**CHANGE ORDER**

No. 1

Contract: Road Maintenance 2016

Project: P160302-1

Johnson St. , St. Rose, LA 70087

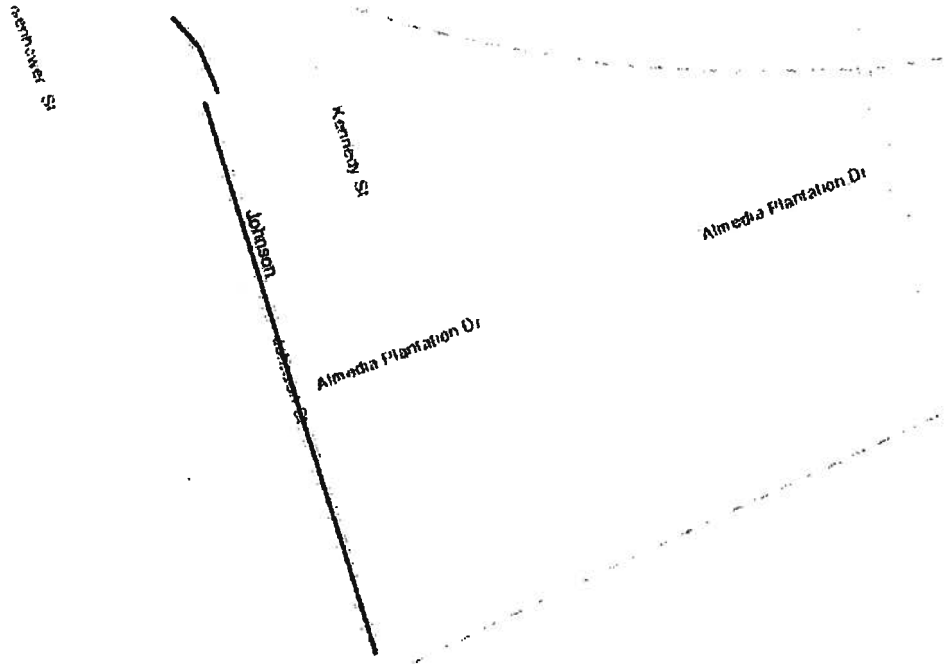
Description: Breaux Ln. was found to be a private street; therefore, it is being removed from the project. The approximate cost savings for not performing work on Breaux is \$12,184.63. Almedia Plantation Dr. and Johnson St. are to be added to the project. Each of these streets will receive patching, mill, overlay, shoulder material, etc. The estimated costs for the additional work are \$49,942.25 for Almedia Plantation Dr. and \$61,101.00 for Johnson St. Mill, overlay, shoulder material, etc. on Kennedy St. will also be added to the project. The estimated cost for the additional work on Kennedy St is \$28,794.50. In addition, a \$7,000 mobilization will be added to the project.
